**ADDENDUM 6**

PROJECT:  
**NEW NAPANEE WPCP**

**PHOTO No.4**  
**BIOGAS FORCEMAIN**  
SCALE: N.T.S.

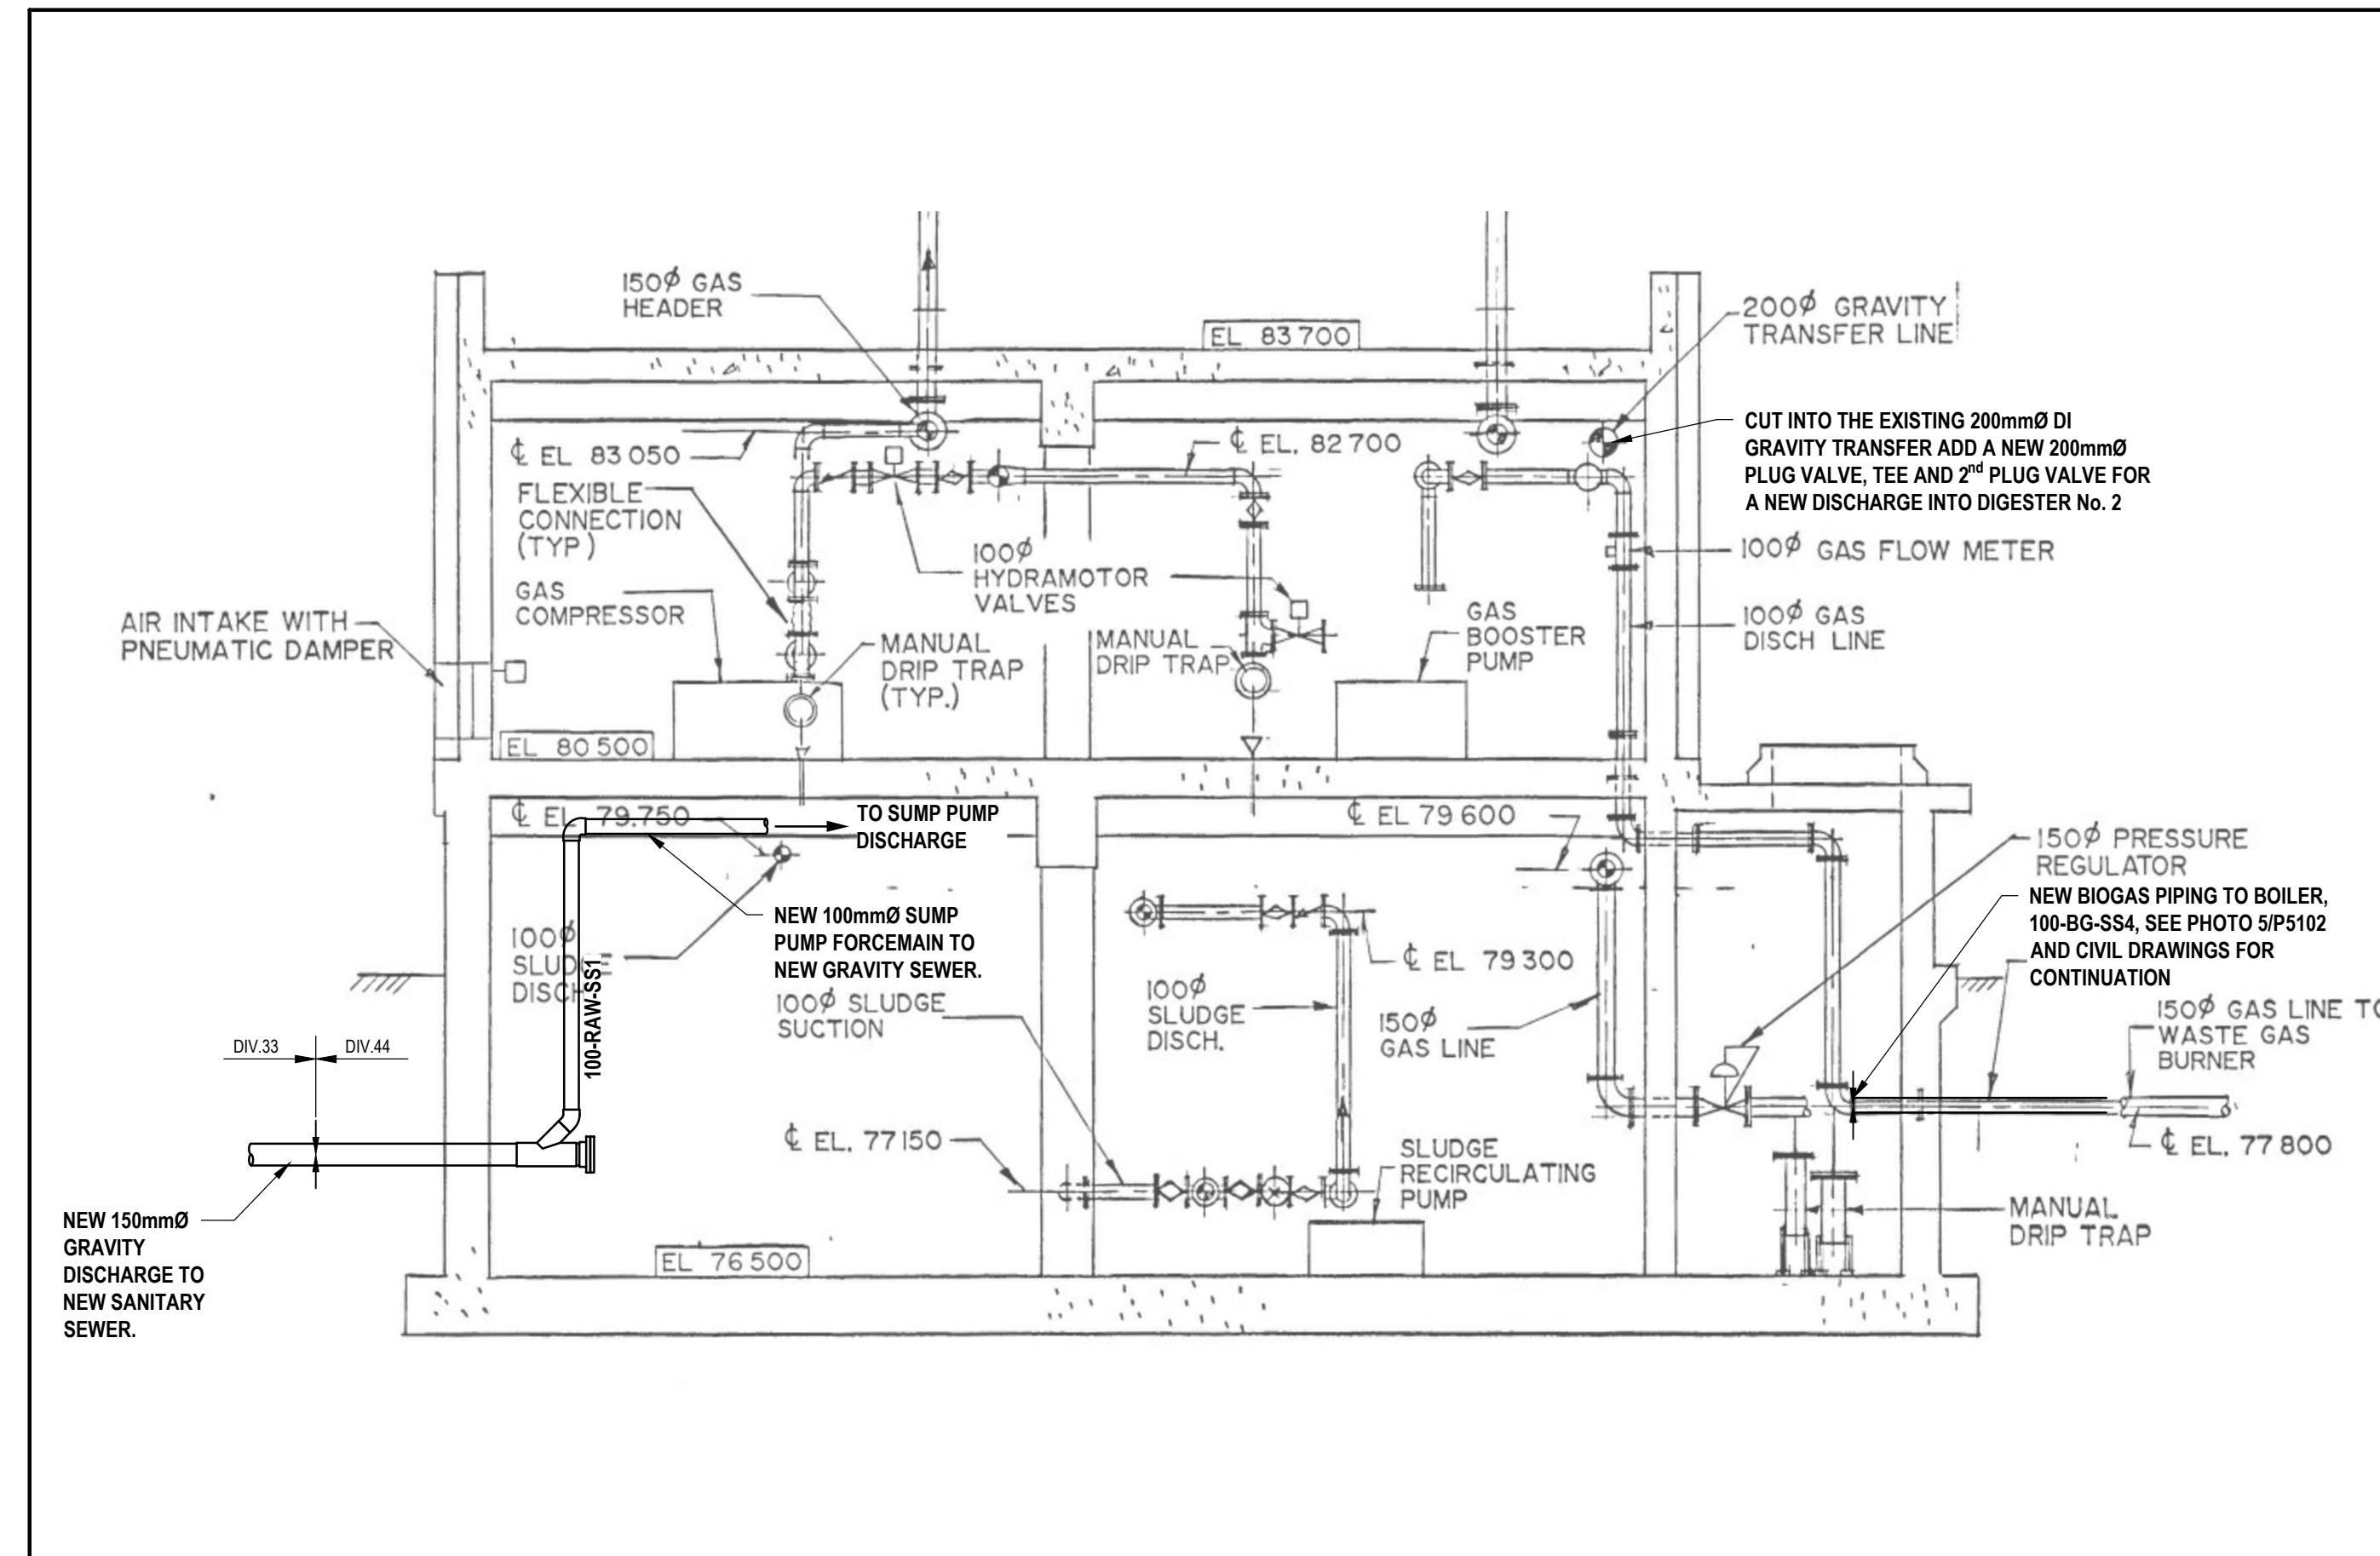
- .10 Drawing P5101
  - .1 **Amend** Drawing P5101 as per the attached.
- .11 Drawing P5102
  - .1 **Amend** Drawing P5102 as per the attached.
- .12 **Add** Drawing P5103 as per the attached.

PD1.1

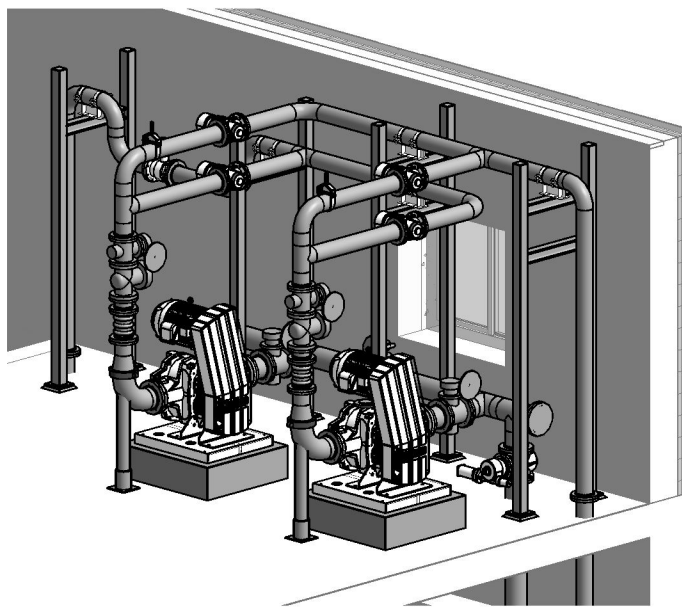
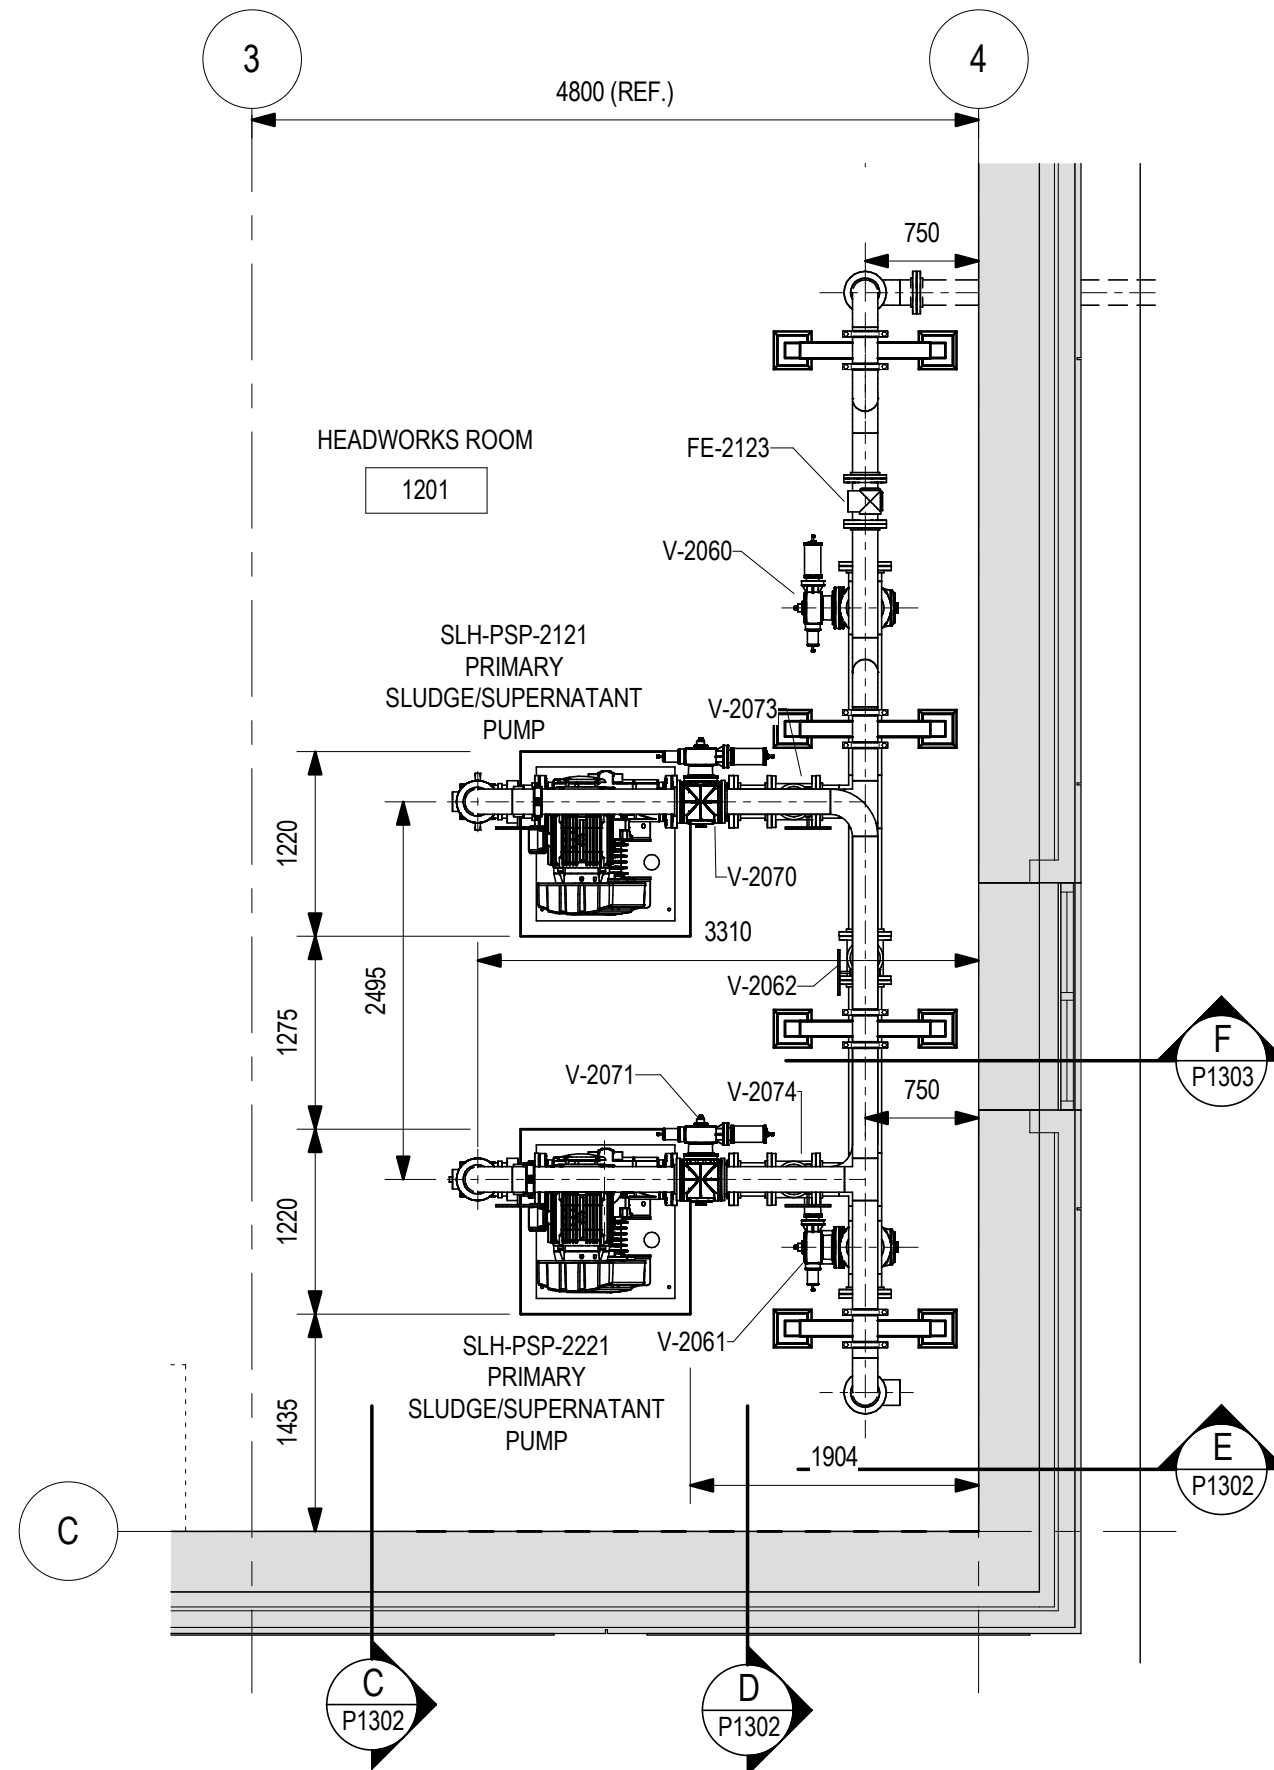
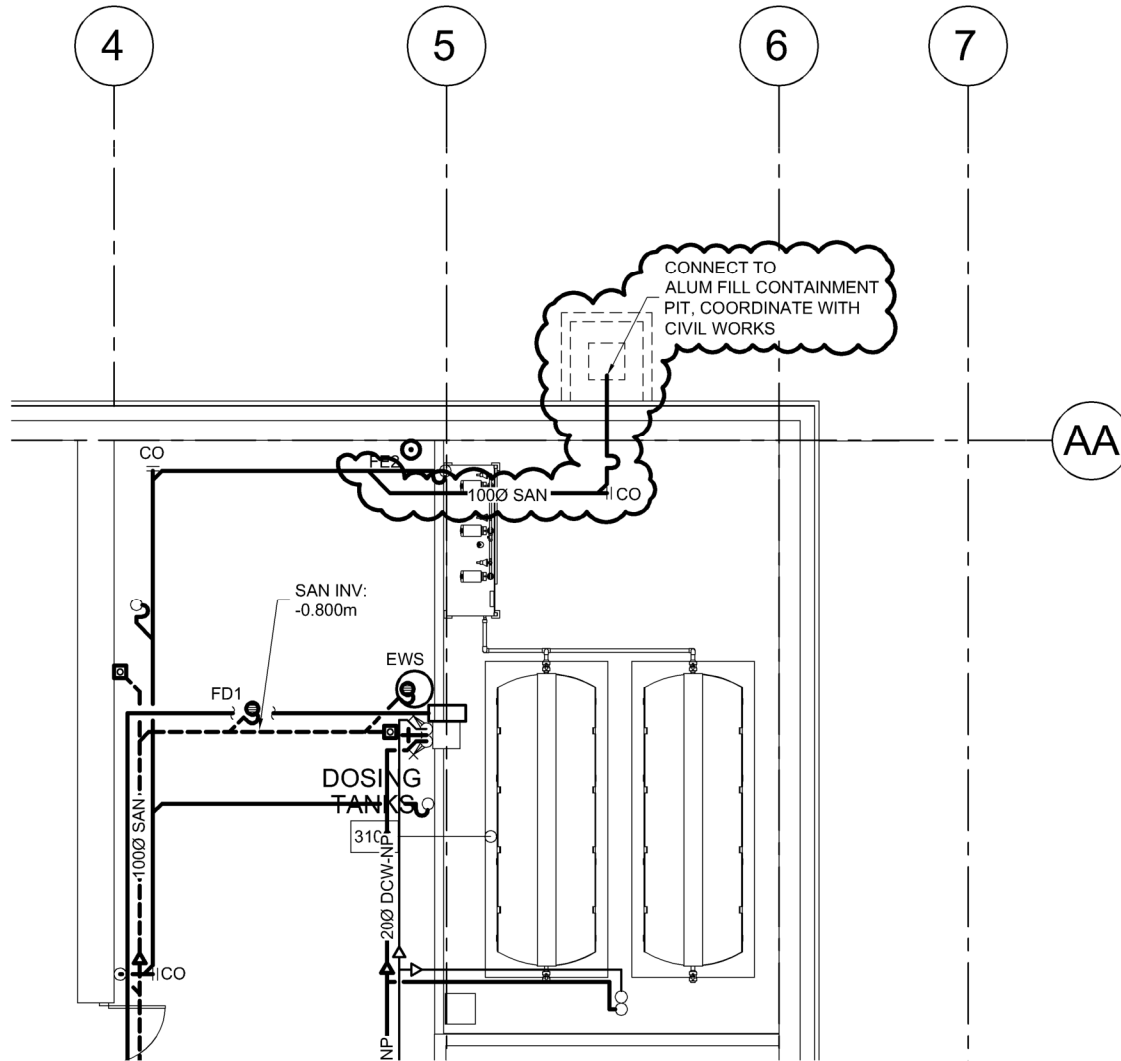
- .8 Drawing P1302
  - .1 Amend Drawing P1302 with the revised pump and layout indicated on the attached sketch PD1.1.
- .9 Drawing P2302
  - .1 **Amend** the call out notes to clarify, 400-AA-SS1 common blower discharge header INV = 81.90m. The 81.970m INV refers to the 250-AA-SS1 discharge header.

A: The pump selection (part of the AASI supply) and arrangement has been modified as part of this addendum. The Olets can be placed on the downstream side of the valve train.

**1 PLUMBING - NEW WORK**  
 SKM1 SCALE = 1:125

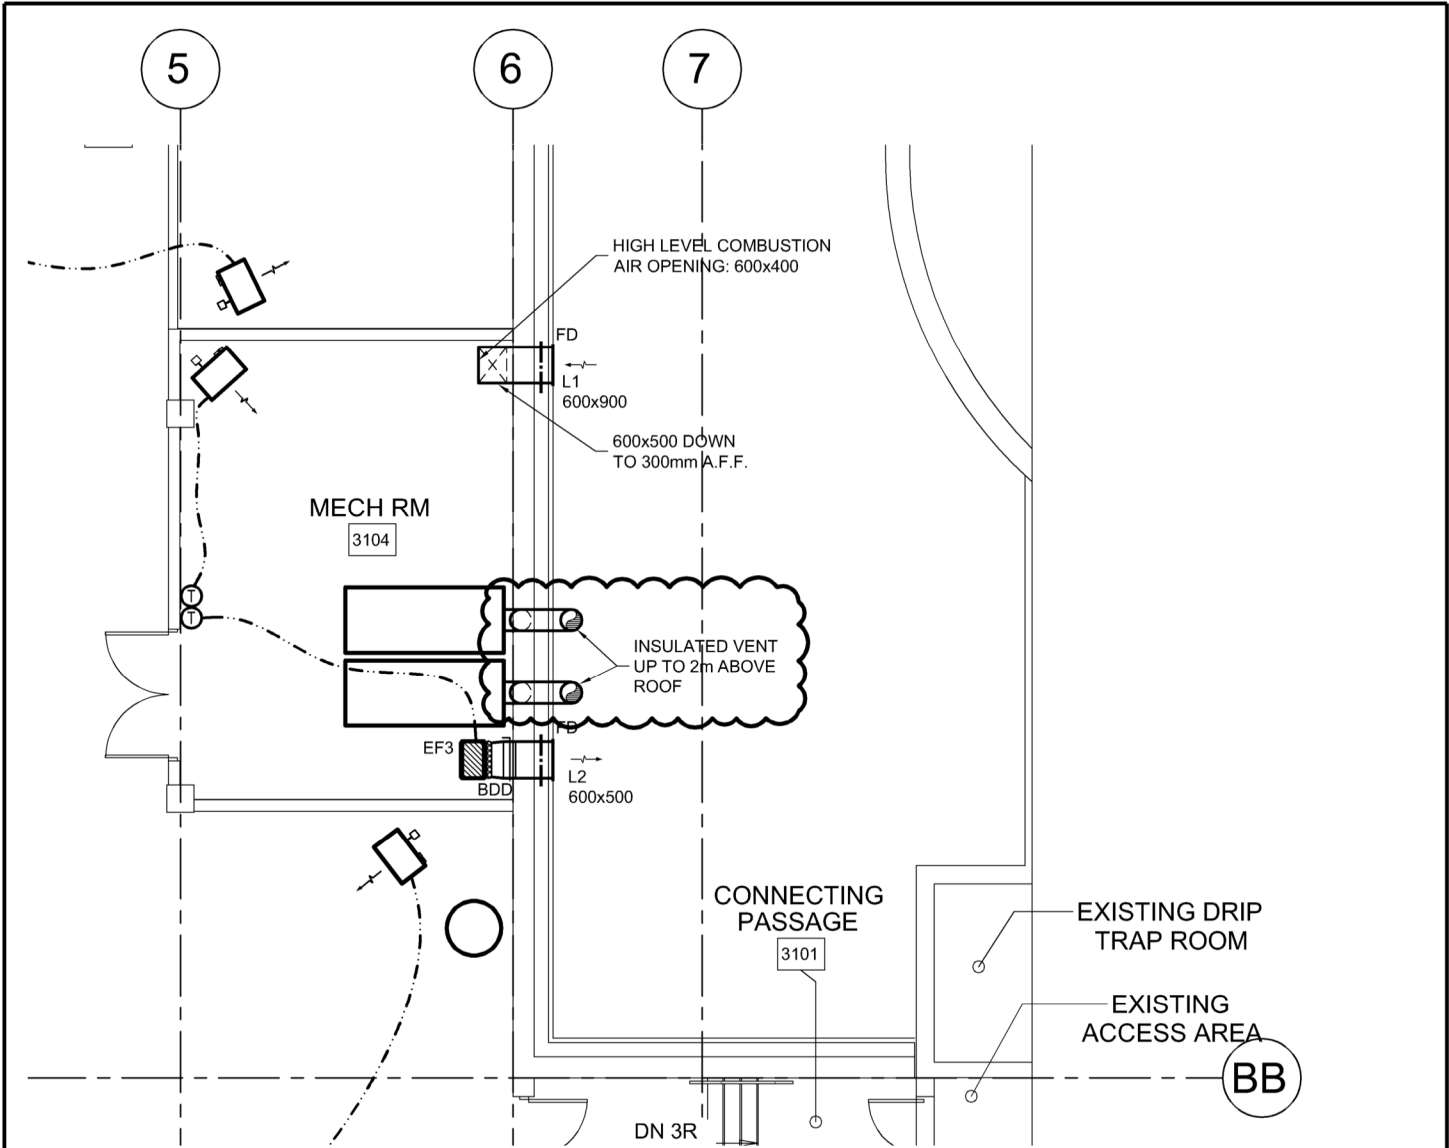
- .1 Operations Building
  - .1 Provide sanitary piping from alum fill containment pit and connect to sanitary piping inside of building. Refer to sketch ADD-M03-SKM1.

|   |  | Approved By J.GORDON<br>Date 2025/03/24 | Approuvé par J.GORDON<br>(yyyy/mm/dd)     | Drawing no. ADD-M03-SKM2<br>No. du dessin  |

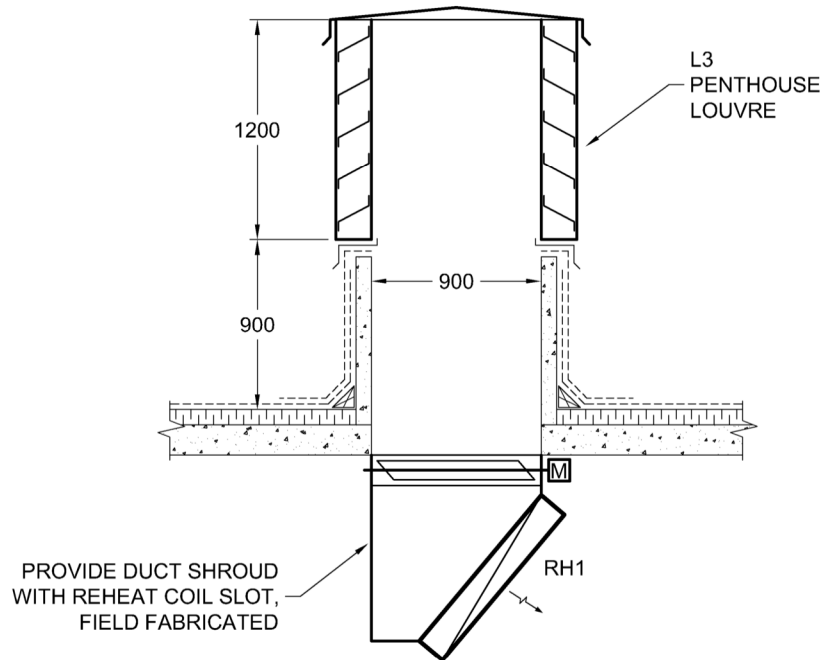
- .2 Provide insulated boiler breeching from boiler up to roof above. Breeching to be insulated. Coordinate with boiler manufacturer. Acceptable material: Duravent or approved equal. Refer to sketch ADD-M3- SKM2.
- .3 Revise penthouse louvre curb height to 900mm. Refer to sketch ADD-M03-SKM3.
